Proposal Description

GTS Holdings LLC

Longview Shores

Skaneateles, NY

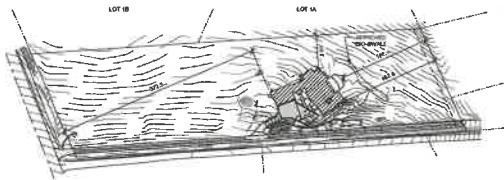
Given the house's location and elevation, the proposed driveway would be quite steep. This would be impractical for guest parking and visually uncomfortable. It would also create a less than ideal transition to the entry walkway.

Redesigning the drive as proposed allows an approach to the home that focuses on the entrance facade rather than the garage, creating a better separation from the shared drive. The proposed parking area will allow for parking and simultaneous use of the garage. It will also allow a small trailer to back into a garage stall. Additionally, this redesign will provide snow storage whereas the current design does not.

S-1

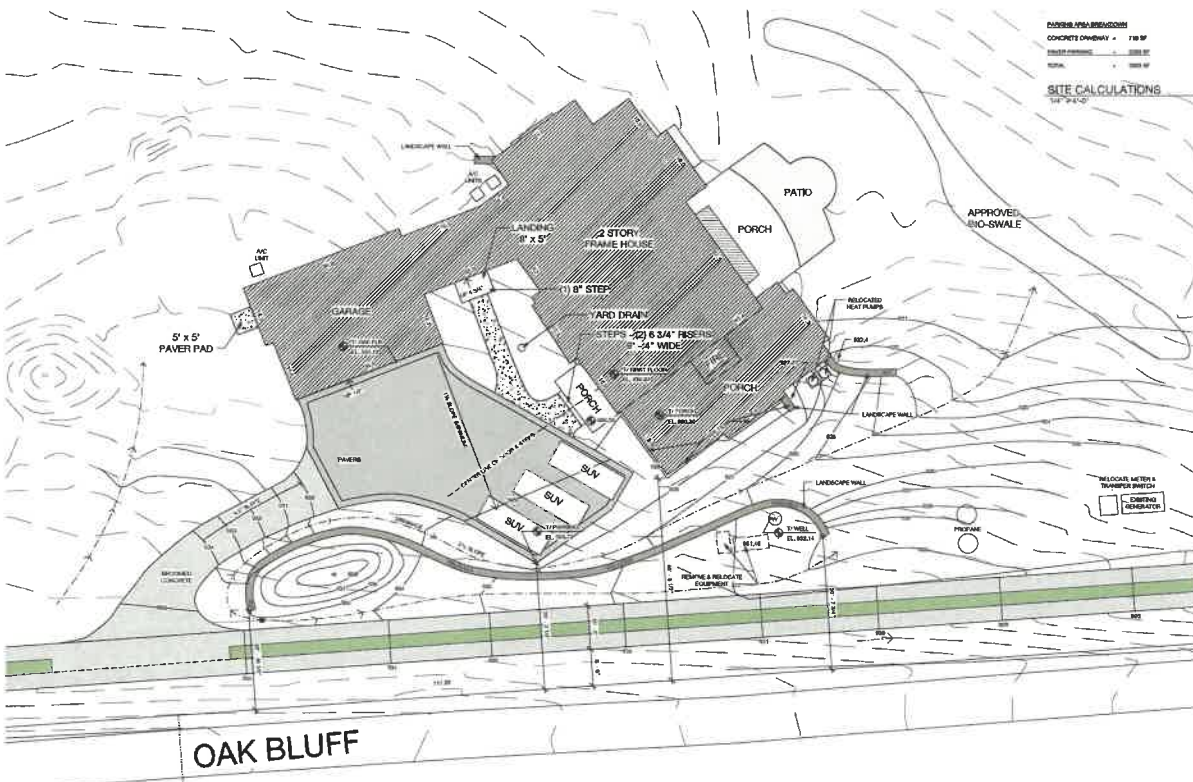
The currently approved shared driveway would be to maintain the existing 9' wide stone drive. We propose widening this driveway to 10 feet (11%). The drive will be rebuilt as a Ribbon Driveway with a 36" grass strip centered between two 42" stone tracks.

Although this change redistributes the existing allowable impermeable surface, it will decrease the impermeable area of the drive, heading directly to the lake with little interruption, by 22% while providing greater drive comfort.

This proposal eliminates the proposed steps and walkways to the South Porch which will be fully enclosed by railing. It also eliminates the North Mud Room entrance, replacing the door (not a required exit) with a window.

This proposed revision to the approved plan neither increases the impermeable area nor changes the property's existing drainage design, exits or devices.
